Value Engineering Study Report

Project: STP- 0007-00(217) - PI No. 0007217

Social Circle Bypass, Newton/Walton Counties

March 12, 2008

Illustration

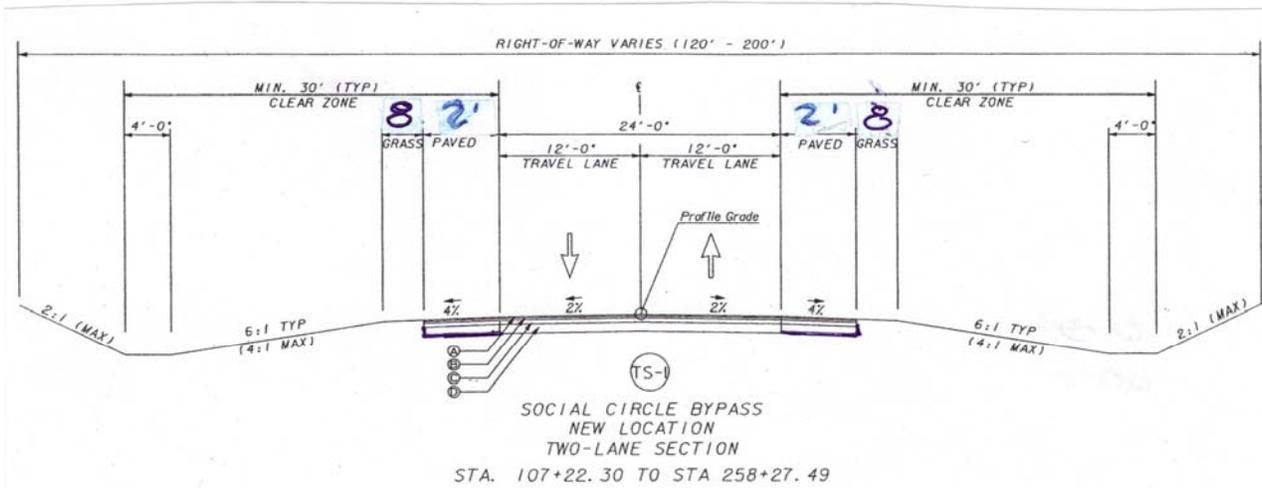
The current design proposes using a 6.5' paved shoulder on the new bypass.

The alternative design proposes using a 2' paved shoulder on the new bypass to match the existing bypass paved shoulder width to the north.

The alternative design proposes using a 2' paved shoulder on the new bypass section. The minimum paved shoulder width for a minor rural arterial is 2'-0" as discussed on page 448 of the 2004 AASHTO green book. The shoulder width on the existing bypass that this extension is connecting to on the north has a 2' wide paved shoulder. Right of Way is not being adjusted since it is being acquired for future 4 lane roadway.

Illustration

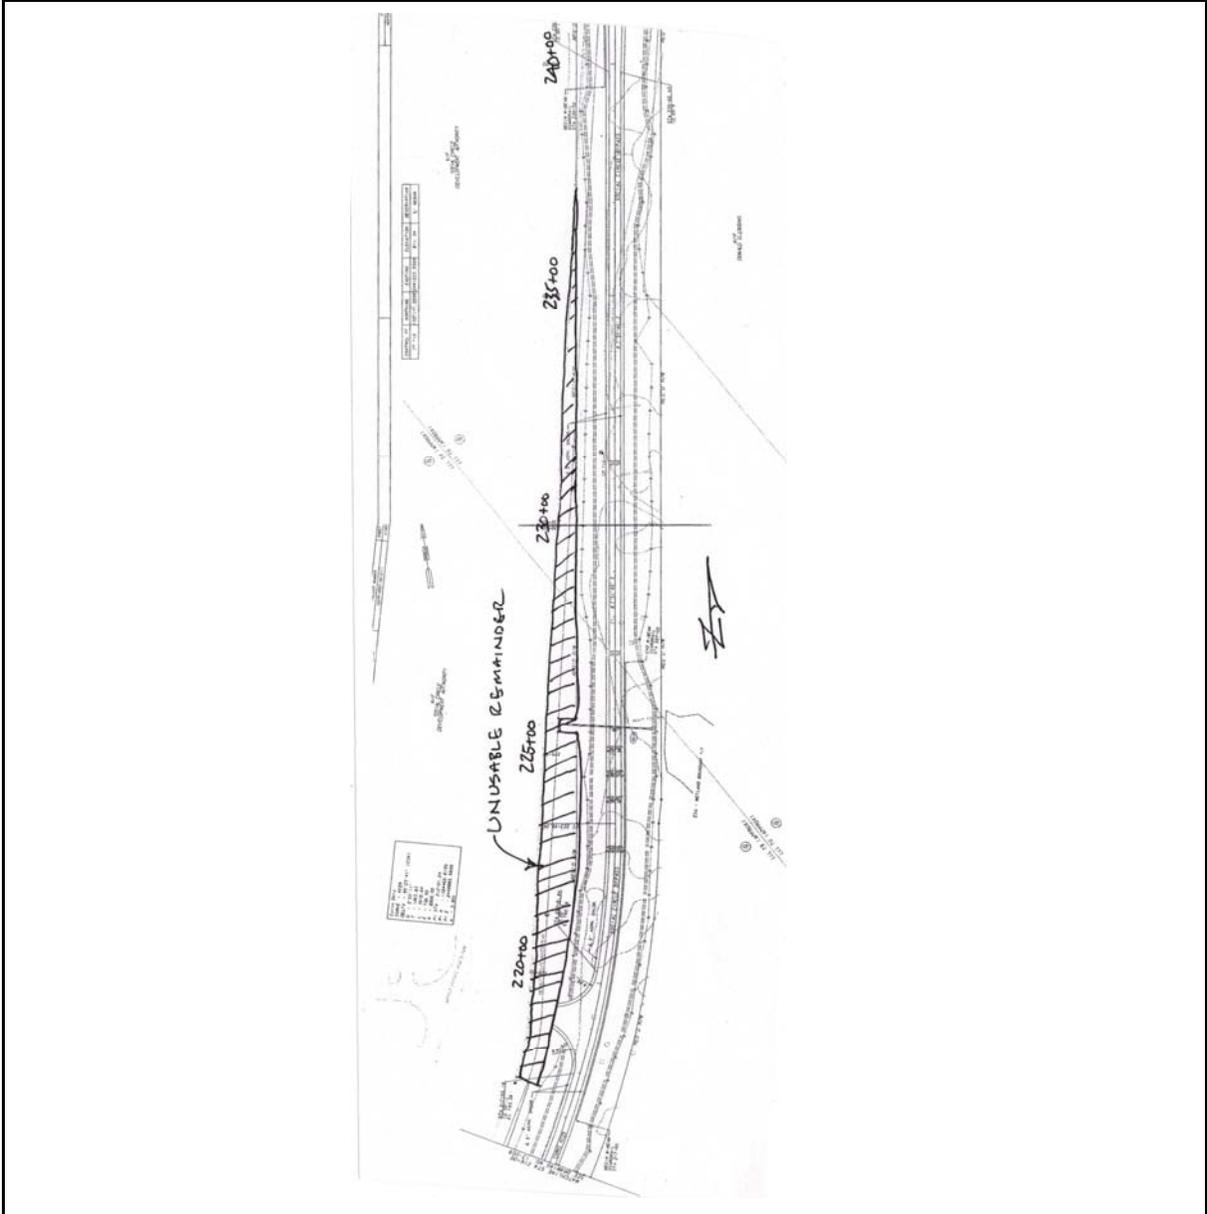
The original design proposes using an alignment that diverges from the Solo Plant Access Road alignment.

The alternative design proposes using an alignment that is parallel to the Access Road from ~Station 218+00 to ~248+50.

The alternative design would move the widening on existing Social Circle bypass further to the East. The re-alignment will come closer to centering the new construction in the existing right of way North of East High Tower Trail. The realignment will require widening the RR crossing and rebuilding the signals however this will also be required under the original design.

Illustration

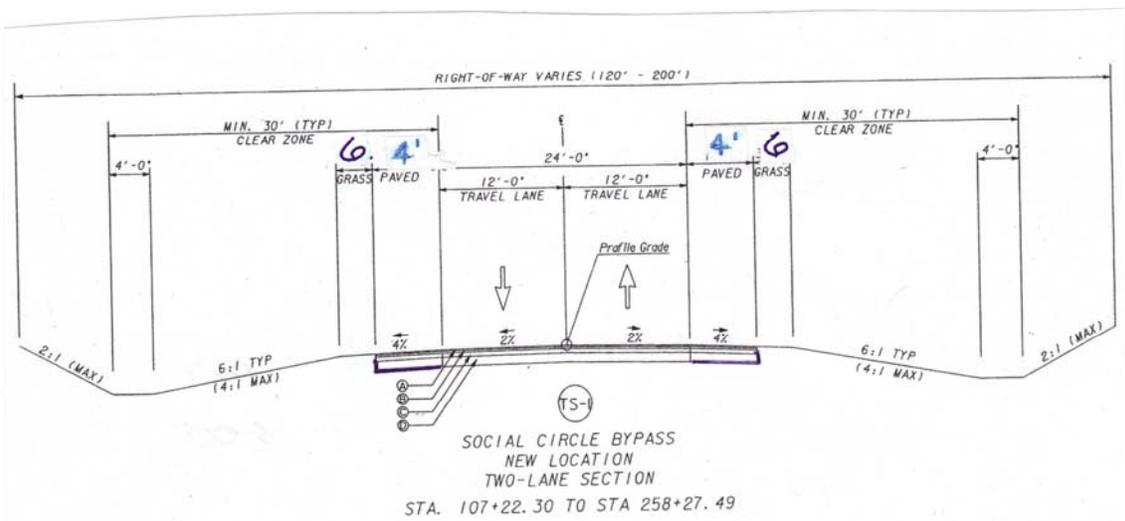
The current design proposes using a 6.5' paved shoulder on the new bypass.

The alternative design proposes using a 4' paved shoulder on the new bypass.

The alternative design proposes using a 4' paved shoulder on the new bypass section. The minimum paved shoulder width for a minor rural arterial is 2'-0" as discussed on page 448 of the 2004 AASHTO green book. Right of Way is not adjusted since it is being acquired for future 4 lane roadway.
